Additions and Renovations
Platt Technical High School
Milford, CT

ADDENDUM NO. 6

August 21, 2019

ROOF FRAMING PLAN - AREA D
SCALE: 1/8" = 1'-0"

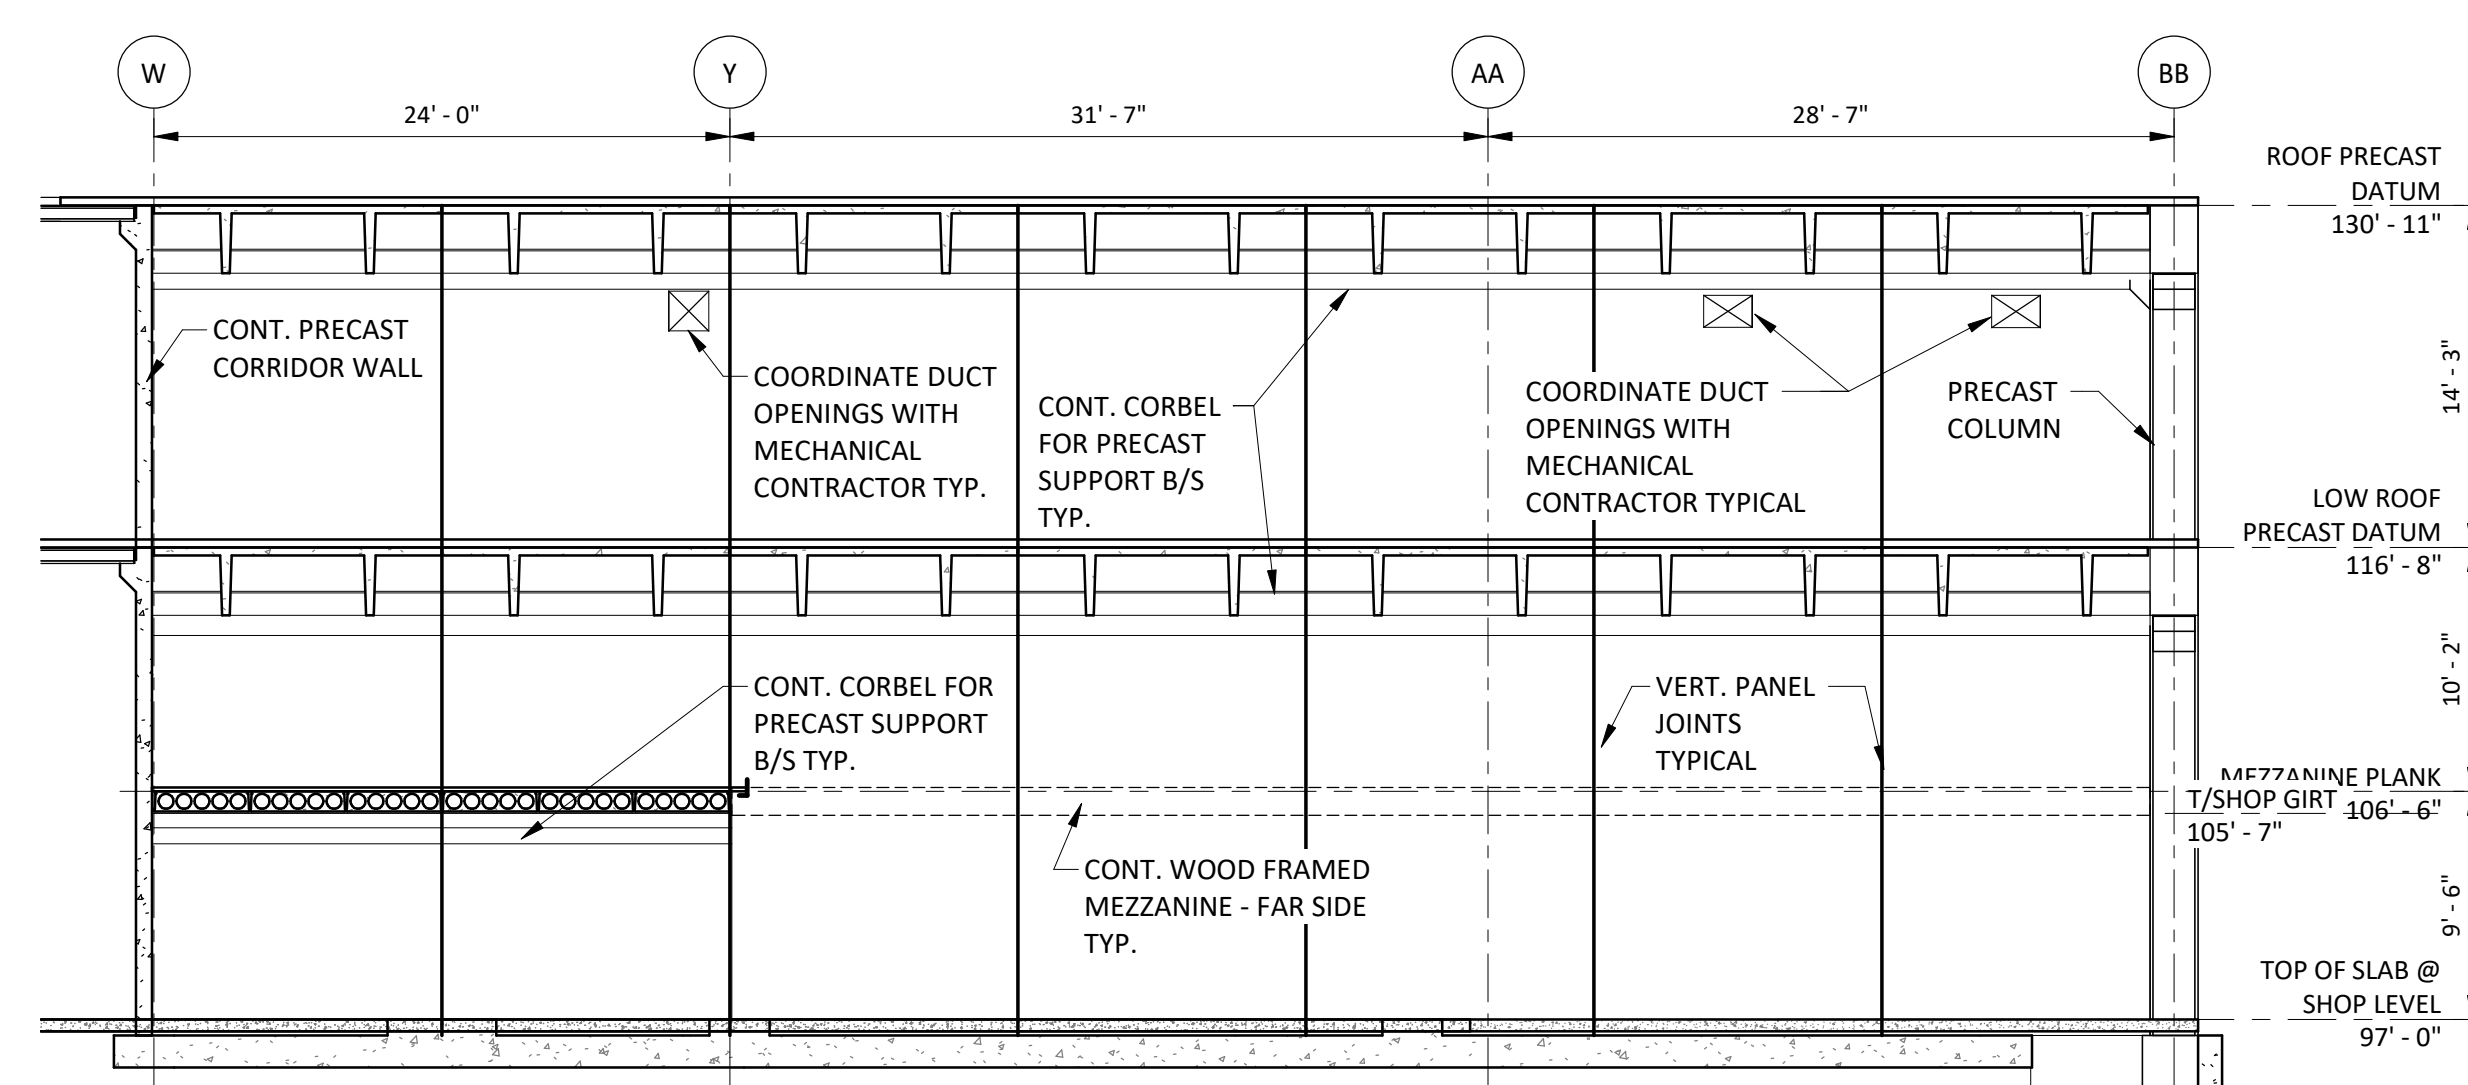
- ADD 6-027 DRAWING S1-1-2 – SECOND FLOOR FRAMING PLAN – OVERALL**
REVISE concrete strength for slabs “S-1” and “S-2” to be 4,000 PSI in the Concrete Slab Table.
- ADD 6-028 DRAWING S1-1-3D – ROOF FRAMING PLAN – AREA D**
ADD Supports for projector screen per Revision RS6-3.
- ADD 6-029 DRAWING S2-3-1 – PRECAST WALL ELEVATIONS**
ADD “Typical Exterior Wall Girt Elevation – Area E and Area F” per Revision RS6-1.
- ADD 6-030 DRAWING S4-2-21– STRUCTURAL SECTIONS**
ADD sections “S12” – refer to Sketch RS6-001.
- ADD 6-031 DRAWING S5-1-1 – STRUCTURAL SECTIONS ROOF**
ADD Section “R8” – refer to Sketch RS6-002.
